APPLICATION TO THE RESIDENTIAL DESIGN
AND COMPATIBILITY COMMISSION (RDCC)

GENERAL MODIFICATION WAIVER

STREET ADDRESS: 1809 Schulle

February 24, 2012

Tree Permit

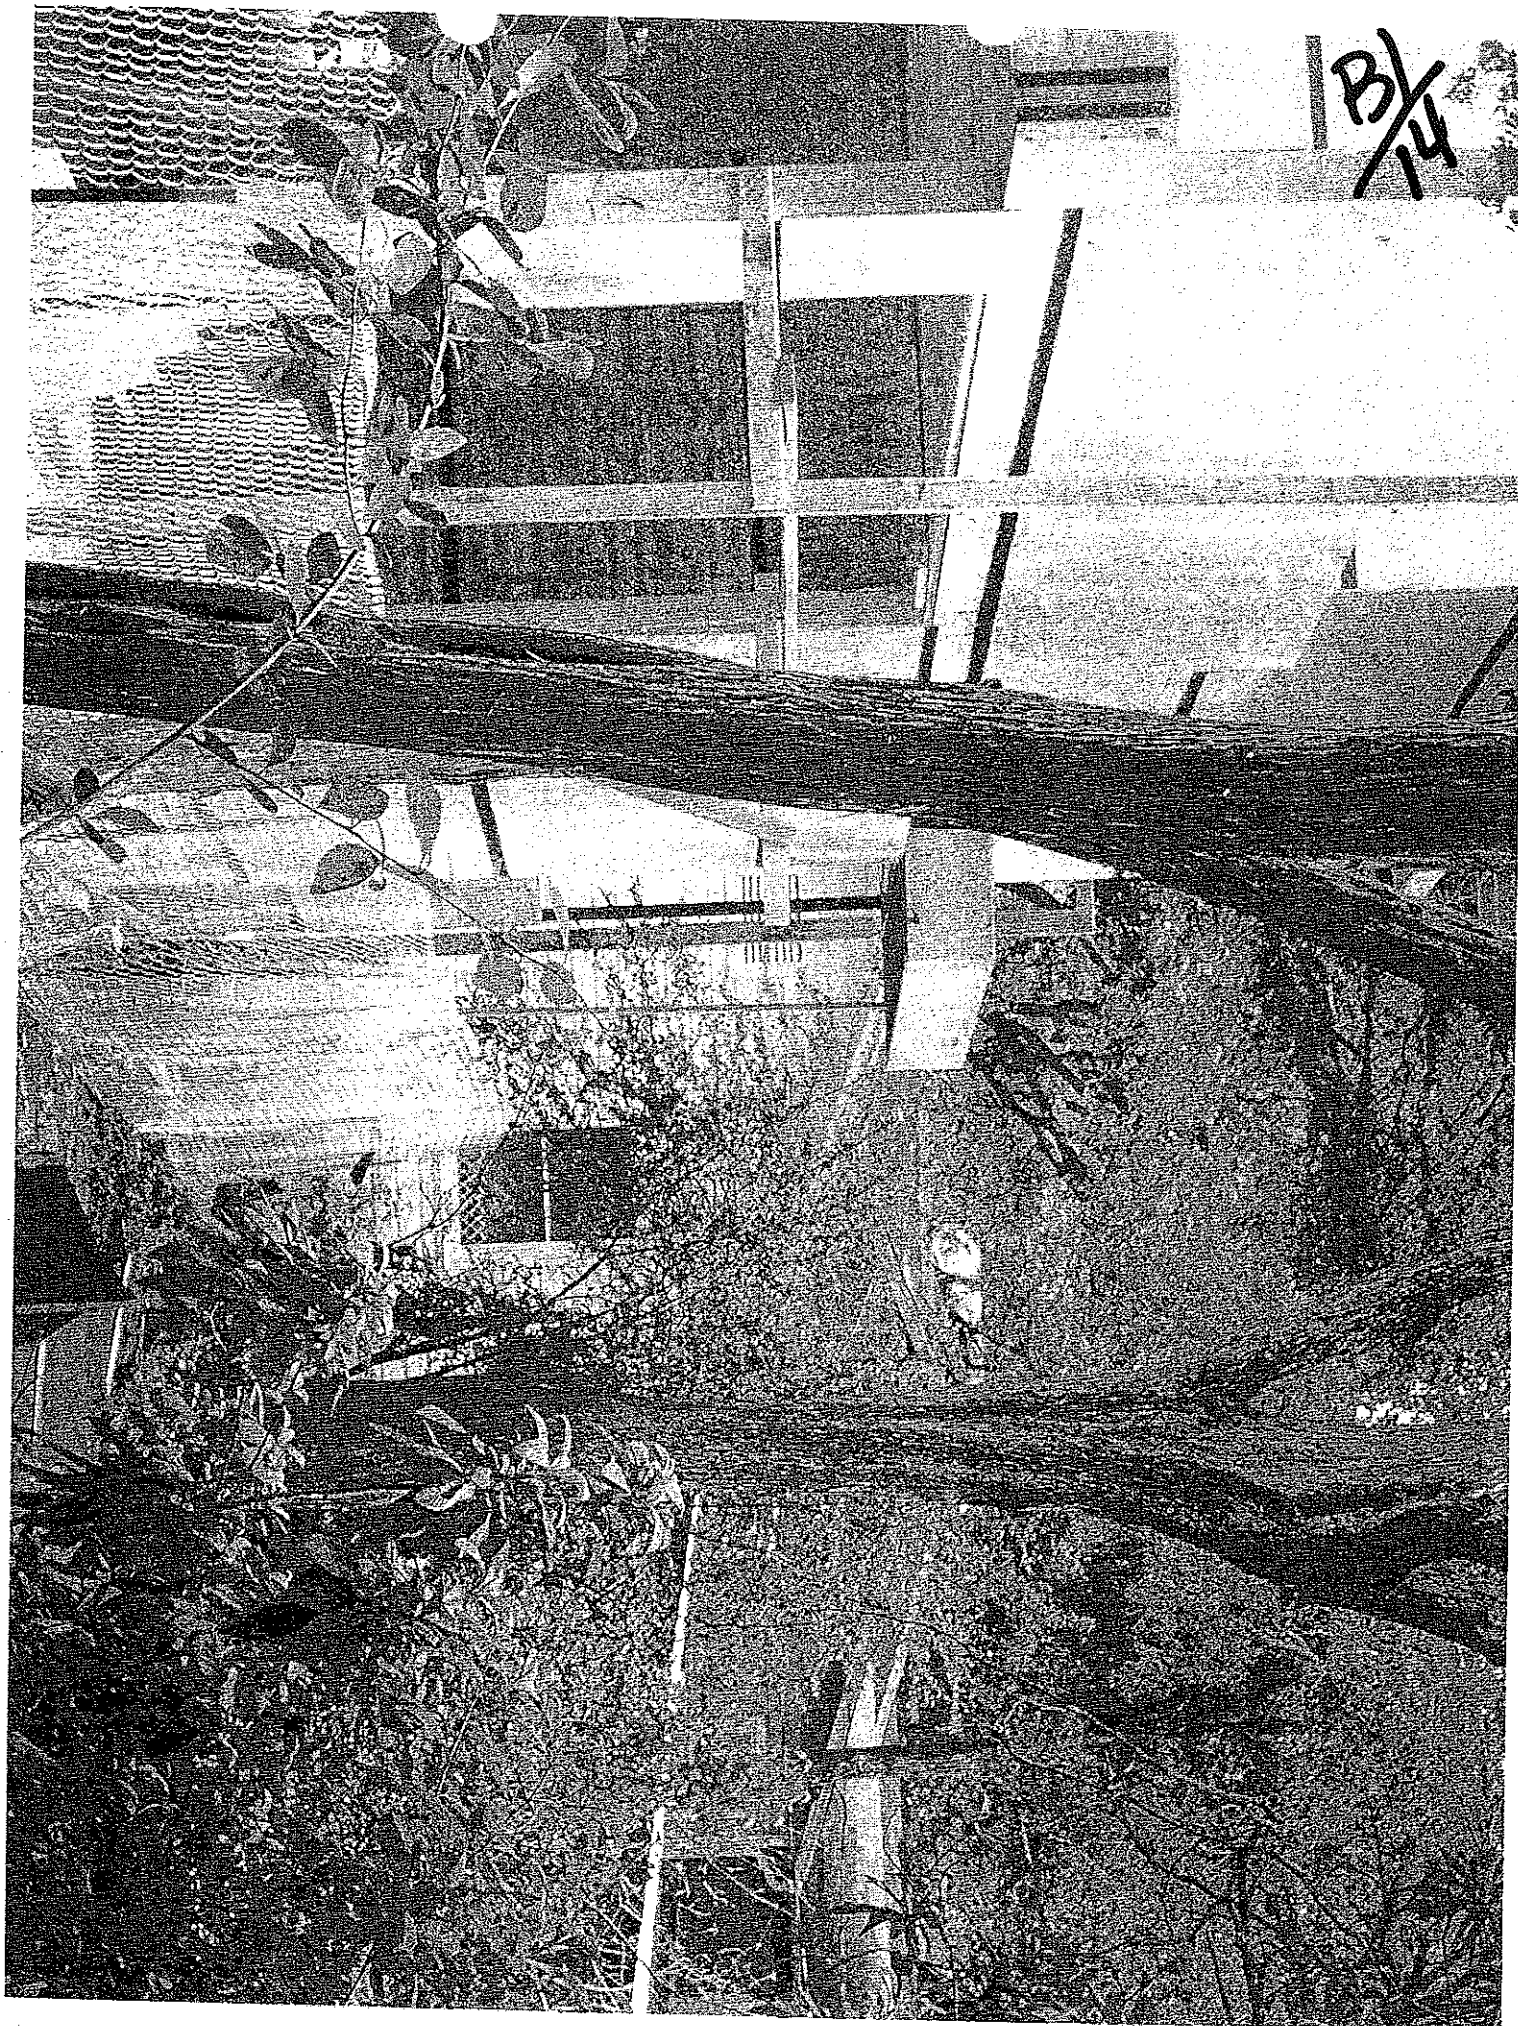
Comments: Per attached plan, no excavation within 13.5' of cedar elm in N.E. corner of lot.

☒ Applicant agrees to plant 21 caliper inches, container grown, City of Austin Class 1 trees* (i.e. Live Oak, Cedar Elm, Mountain Laurel) on the lot prior to obtaining a Certificate of Occupancy (minimum 2-inch trunk diameter).

☒ Prior to development, applicant agrees to supply an 8-inch root zone mulch layer and maintain tree protection fencing (chain-link, five-foot in height) throughout the project duration.

☒ No impacts are permitted within the tree 1/2 critical root zone (*ECM 3.5.2), including trenching for utilities.
